**CITY OF LINO LAKES  
ENVIRONMENTAL BOARD MEETING**

**ENVIRONMENTAL BOARD  
AGENDA ITEM 6A**

**REQUEST:** 601 Apollo Drive Retail Site Plan Review

**EROSION  
CONTROL PLAN**

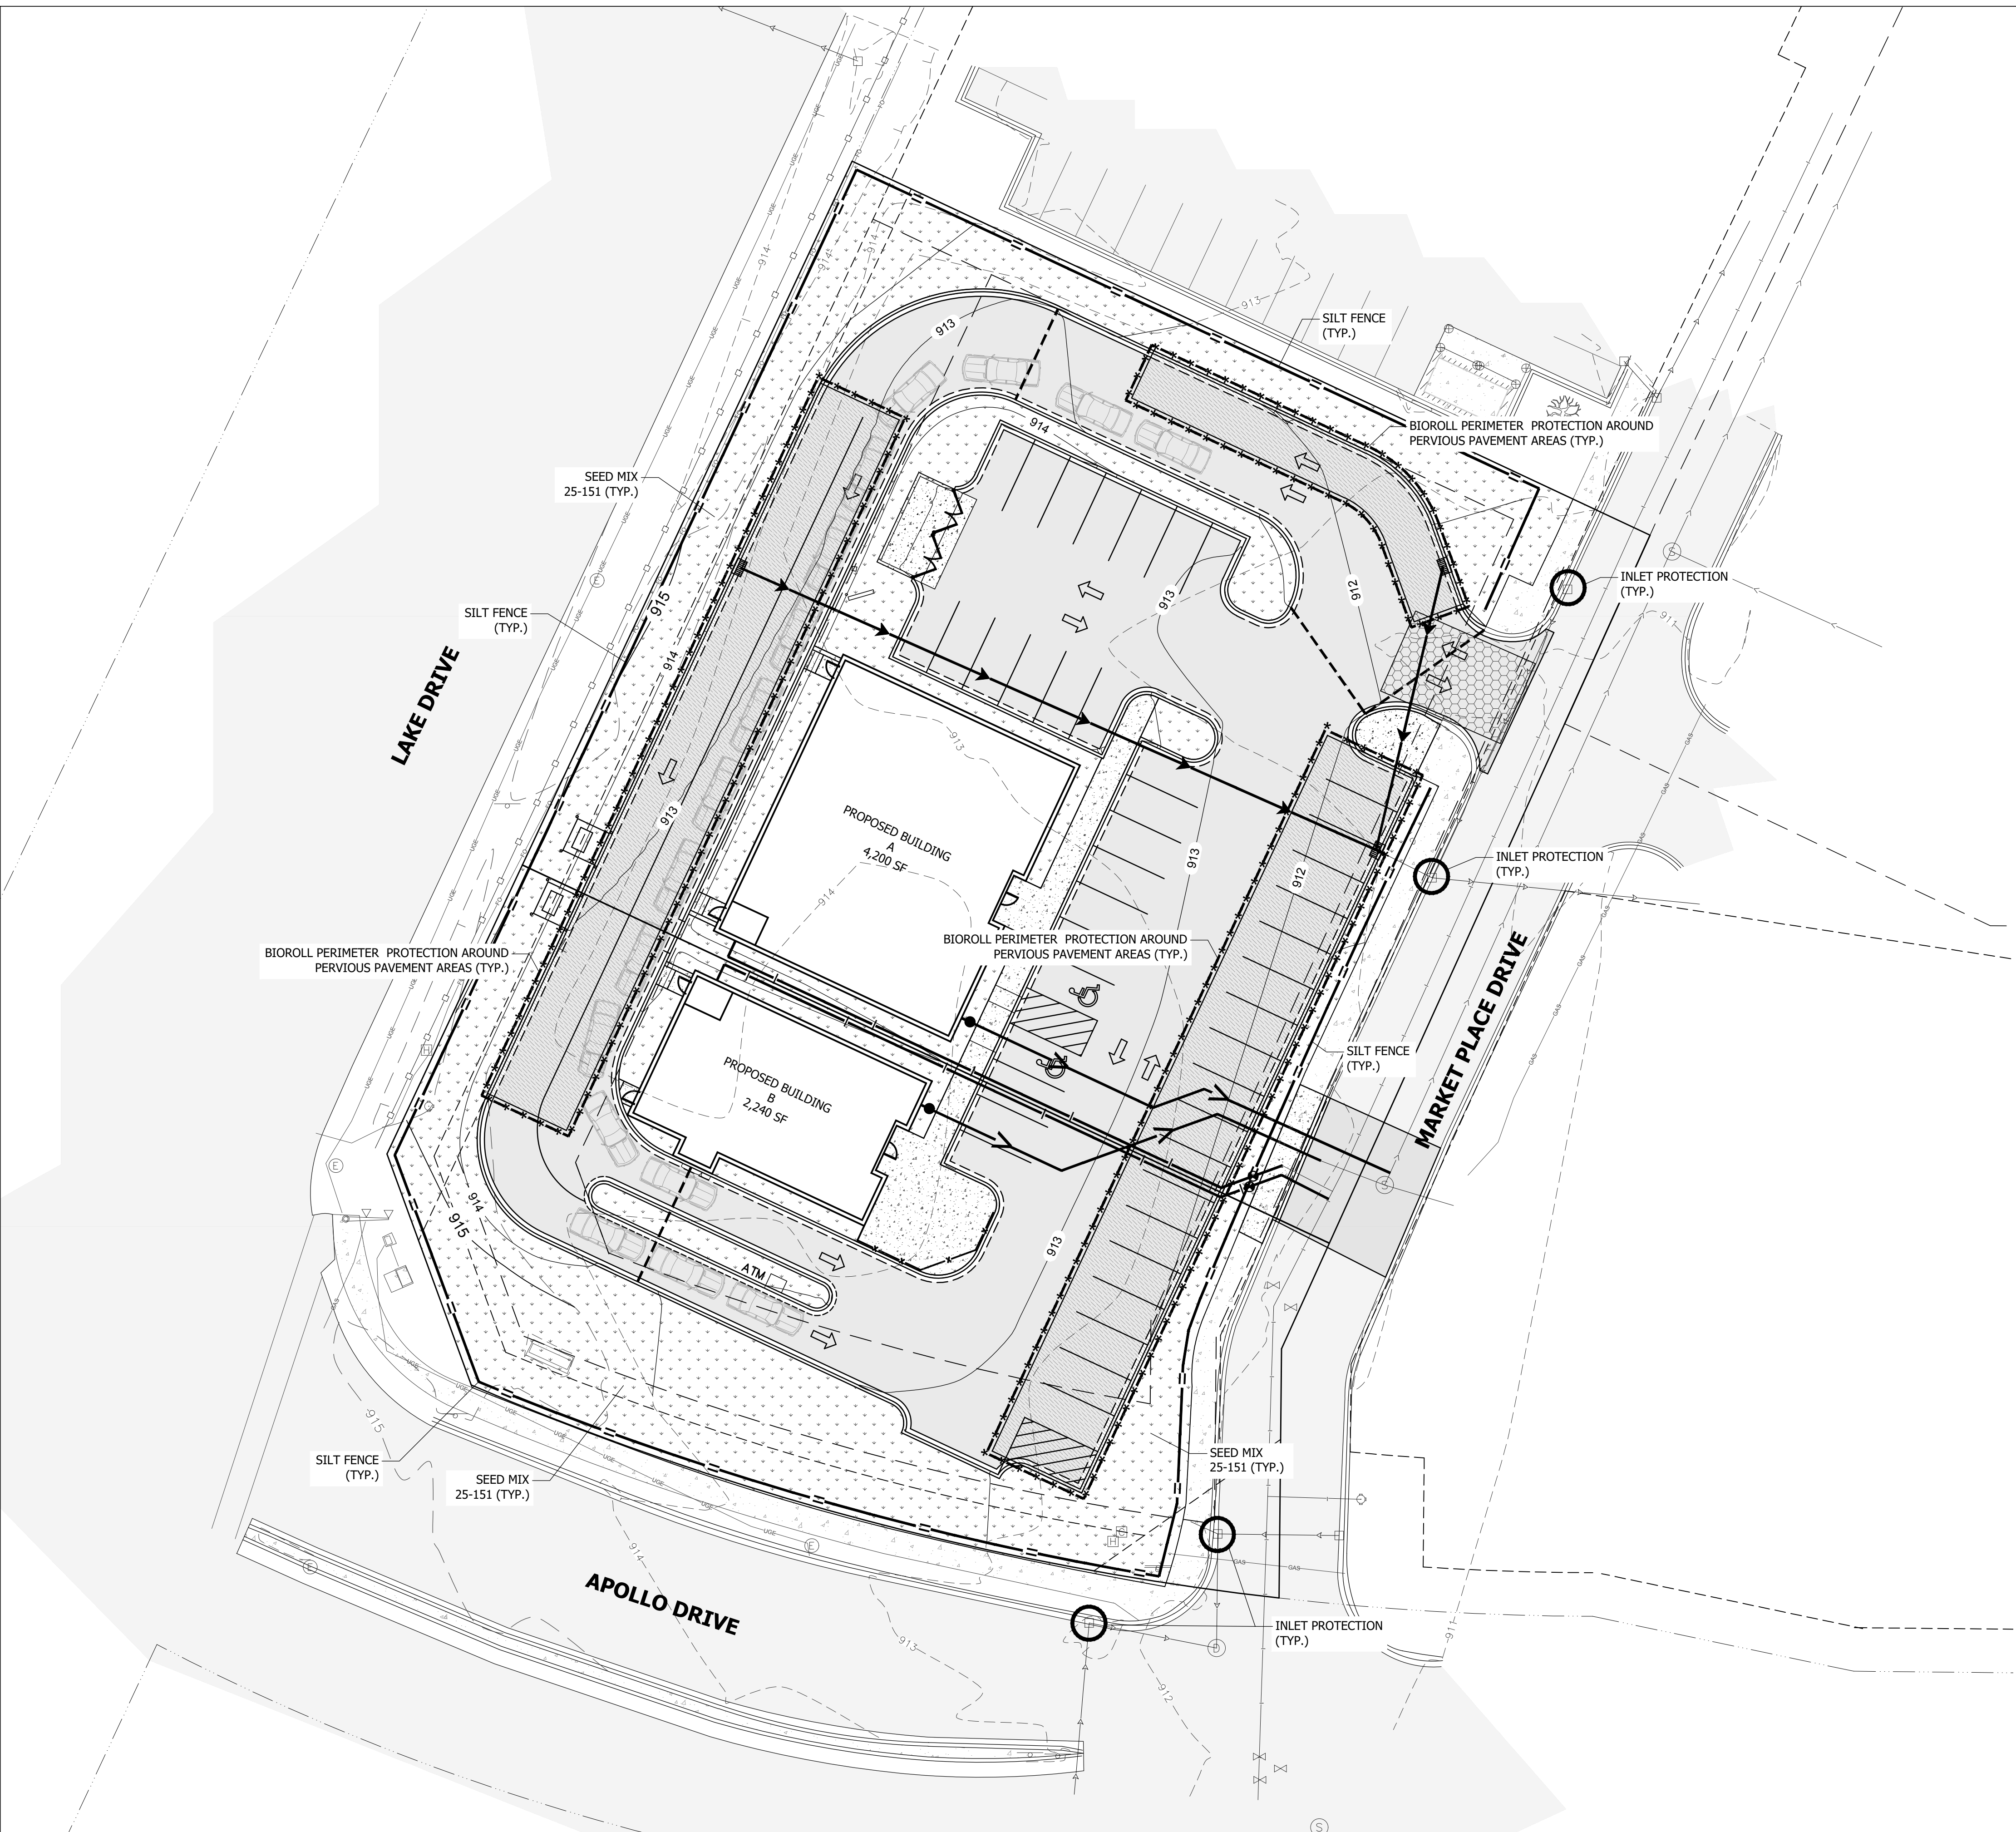
The Erosion Control Plan calls for inlet protections, a rock construction exit, silt fence for perimeter control, and biorolls to prevent sediment from reaching the porous paver BMP's prior to soil stabilization.

Being that this site will drain to impaired waters, George Watch Lake and Marshan Lake, stabilization of exposed soil areas must occur within 7 days after the construction activity in that area permanently ceases. This is noted in the SWPPP narrative.

**LANDSCAPE  
 PLAN**

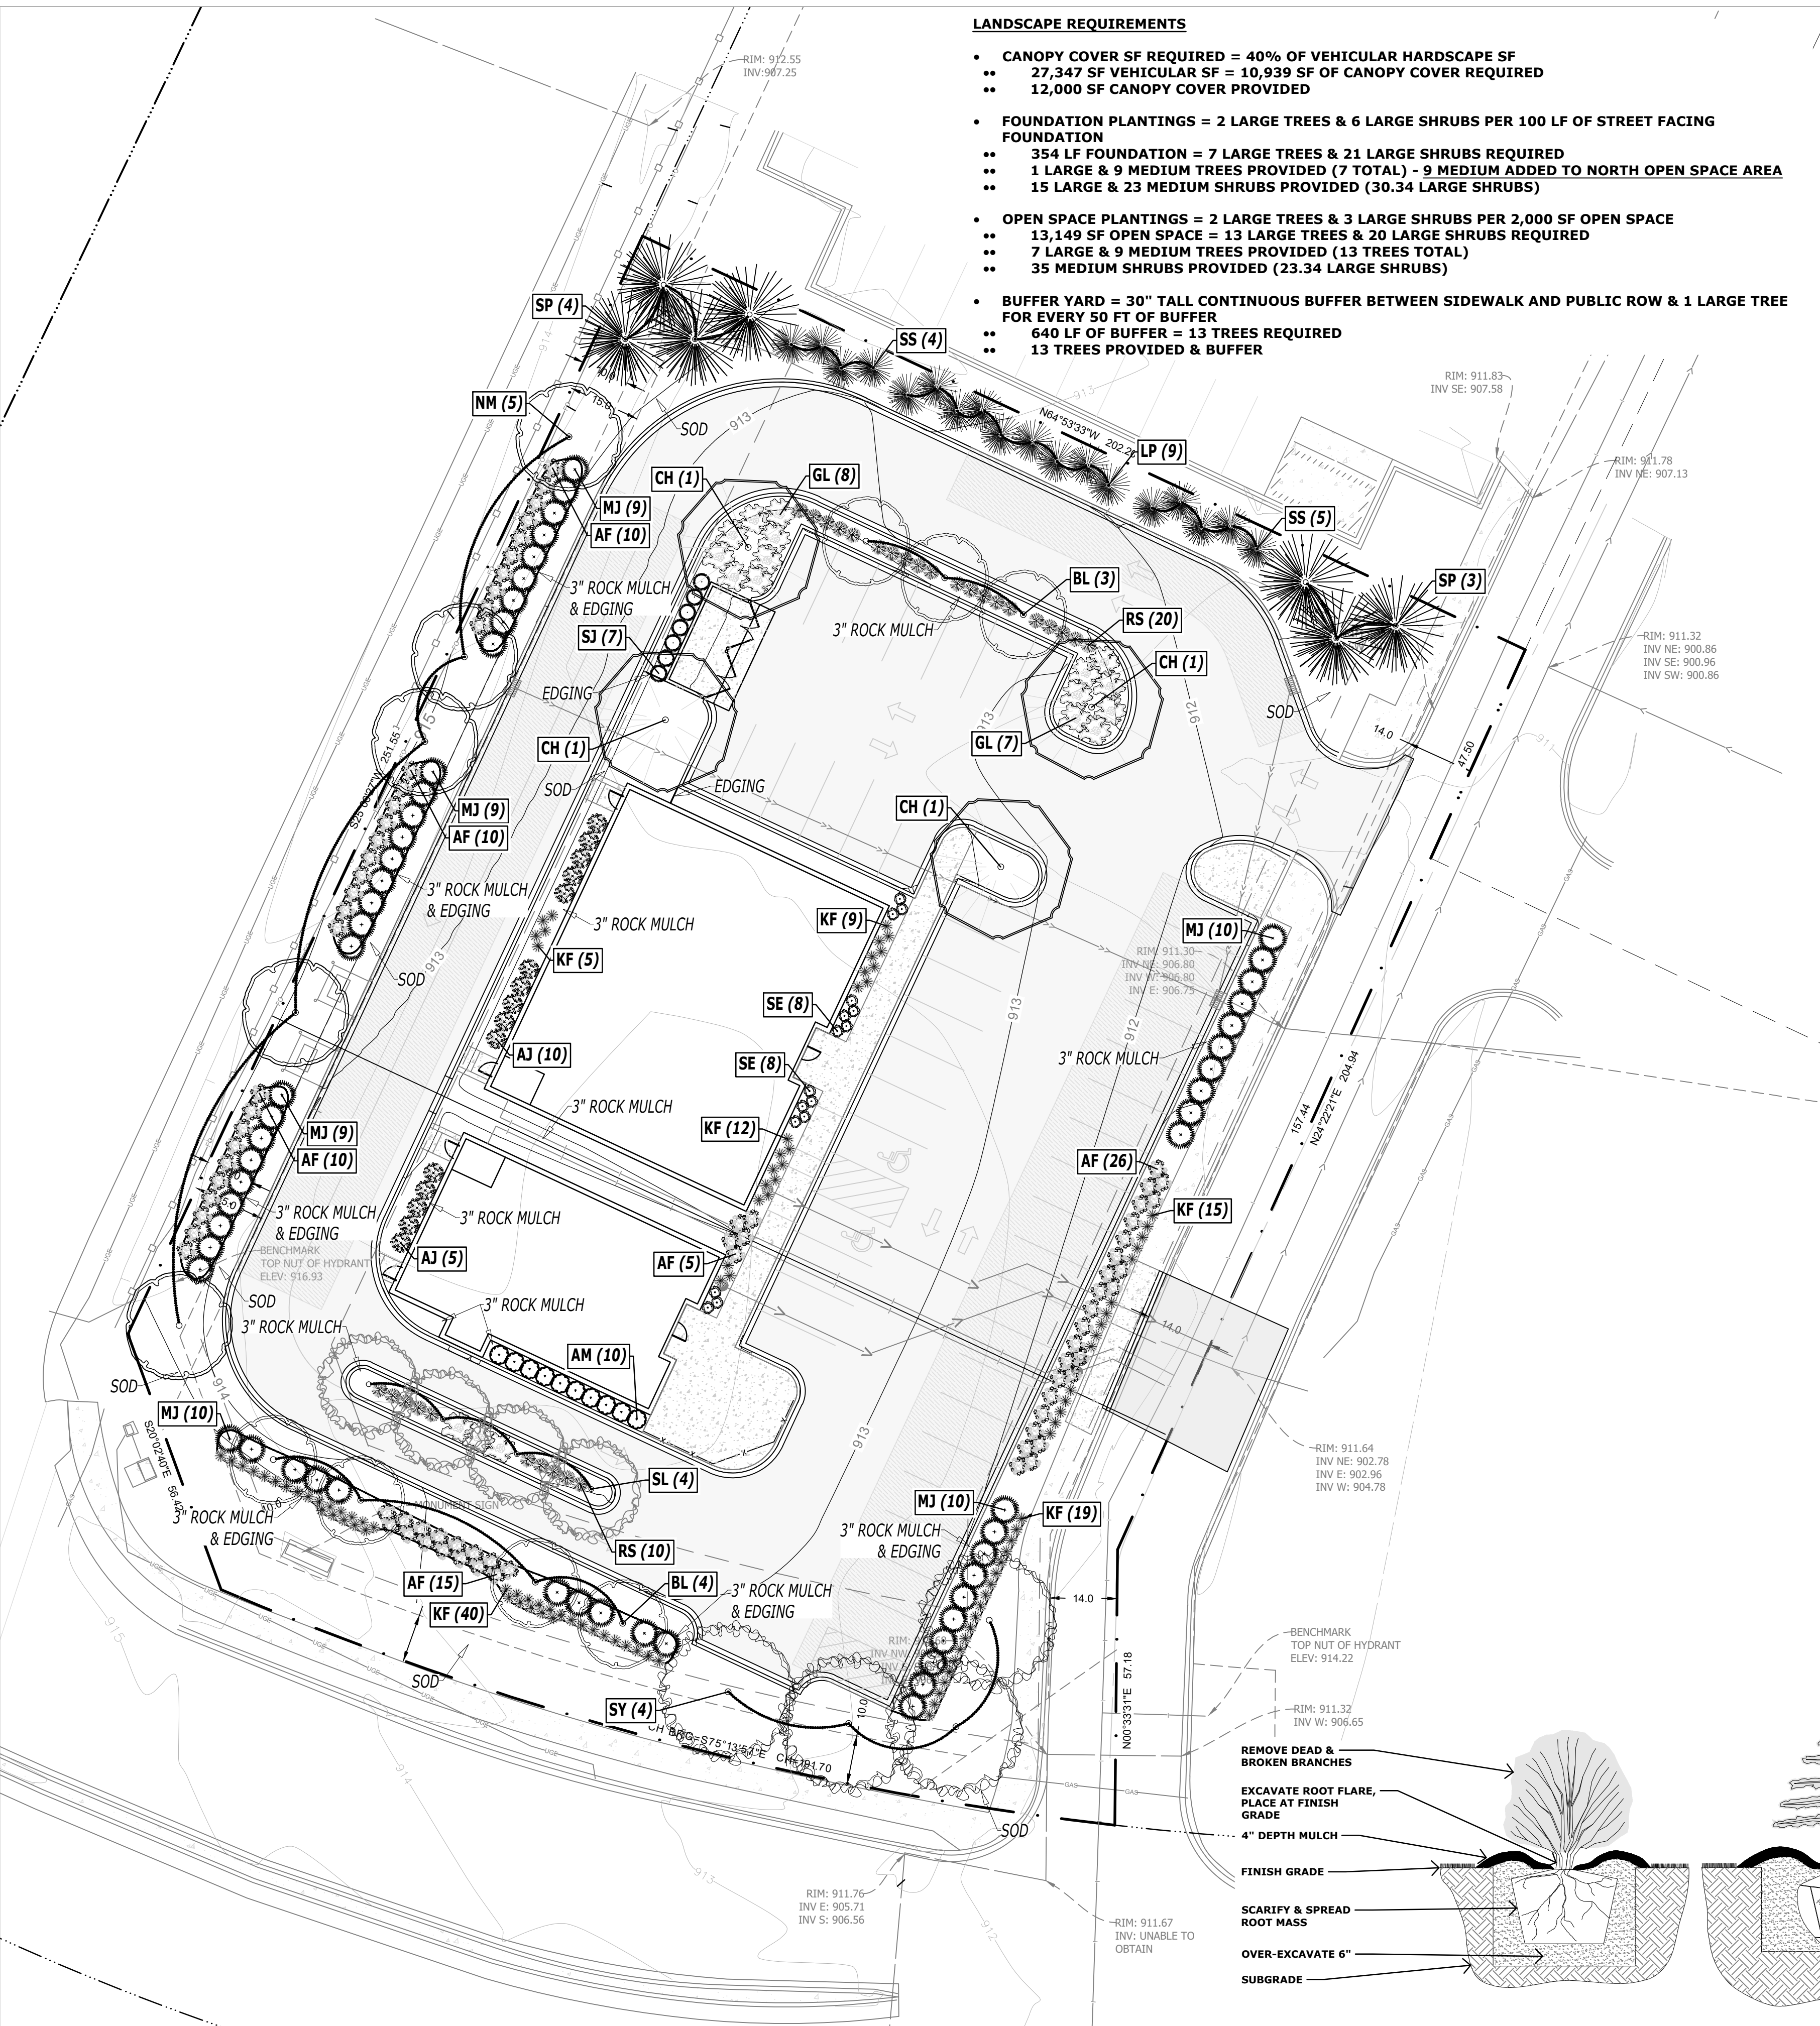
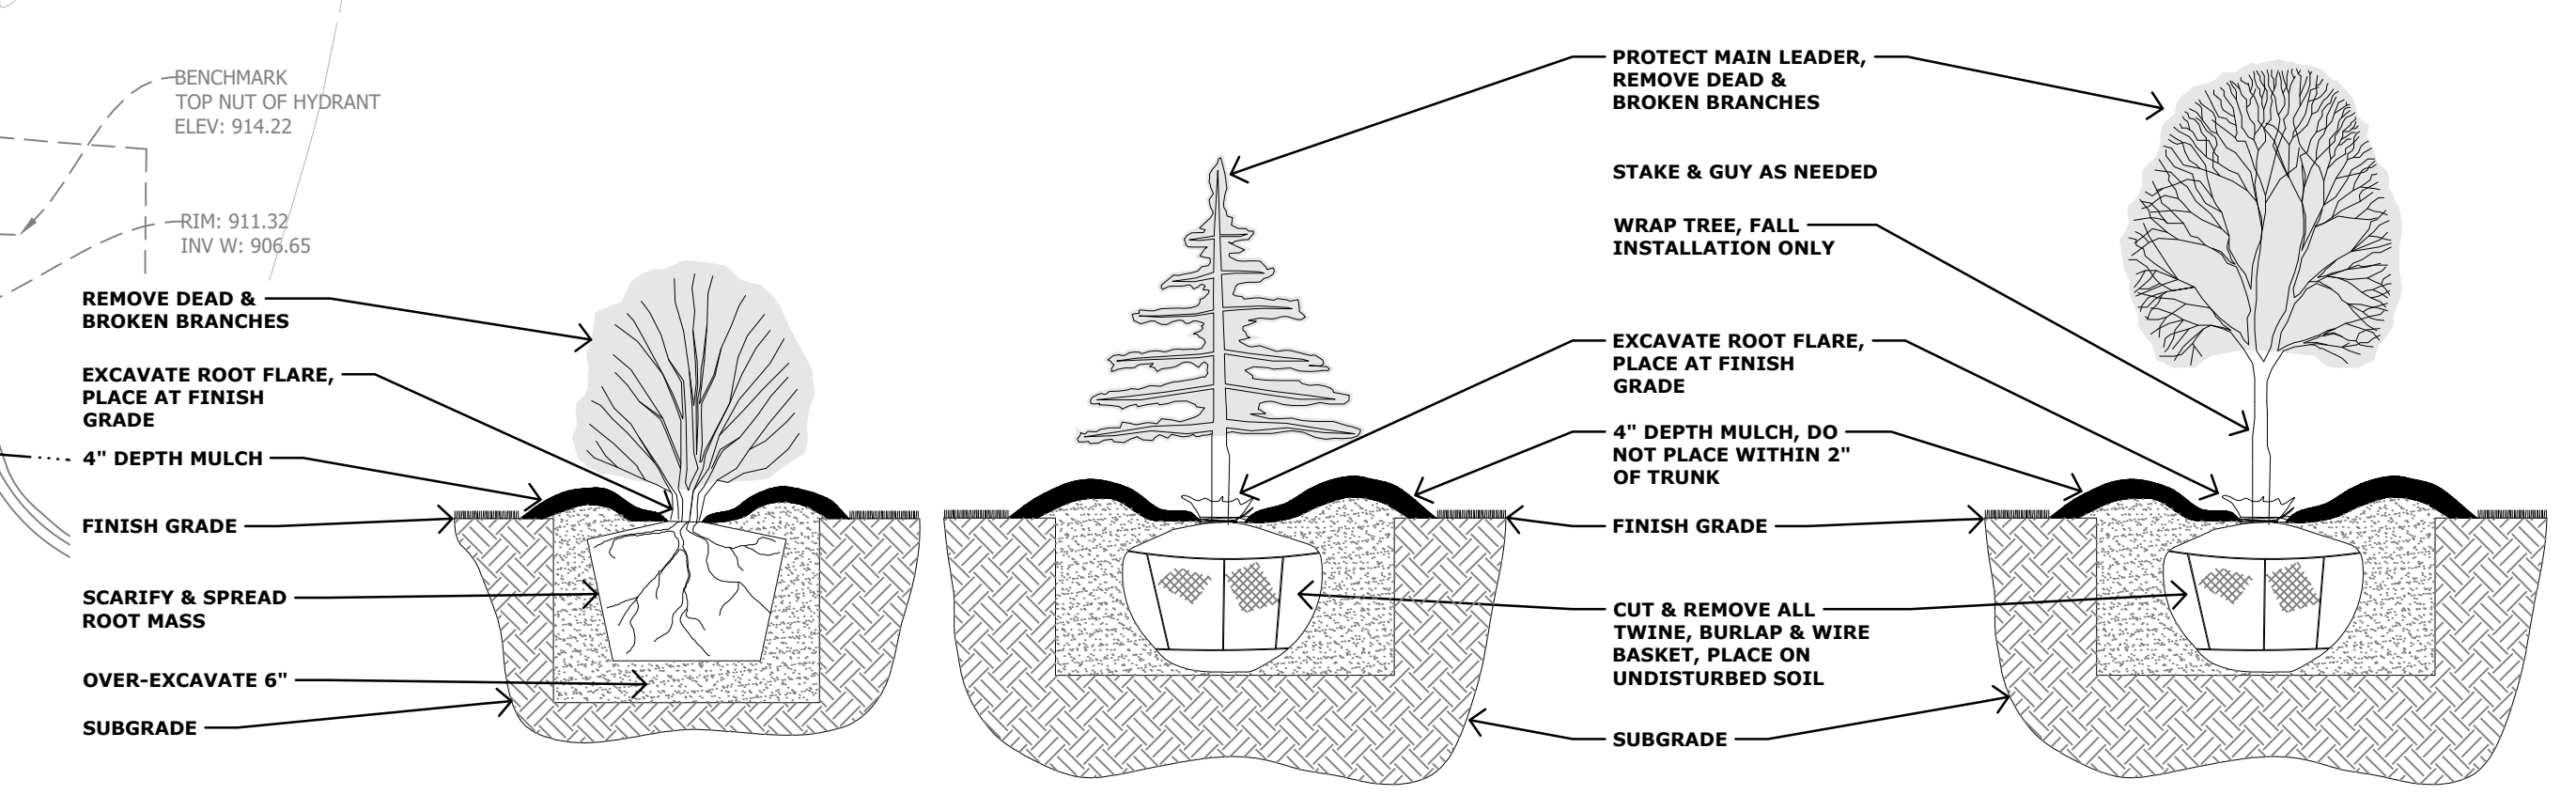
The landscape plan submitted for the 601 Apollo Drive Retail project should thus be measured against the approved Master Landscape Plan from 2001, rather than strictly adhering to current ordinance.

The submitted landscape plan is an improvement upon the Master Landscape Plan in several respects.

- The 2001 plan called for 34 large tree equivalents and 29 large shrub equivalents. The current submittal calls for 47 large tree equivalents and 110 large shrub equivalents.
- The ash trees (*Fraxinus pennsylvanica*) called for on the south perimeter have been replaced with lindens (*Tilia Americana*) and sycamores (*Plantanus x acerifolia* 'Morton Circle').
- The current plan calls for additional trees on the borders shared with Lake Drive, the property to the north, and Apollo Drive. This provides buffer and screening, which will improve the aesthetics of this corner lot.
- There are more trees in the parking lot islands to provide additional canopy cover and shading of the vehicular hardscape area.
- Numerous shrubs have been added in the foundation landscape area.
- Diversity of plant species has increased significantly as compared to the 2001 landscape plan.

Landscape requirements have been met.
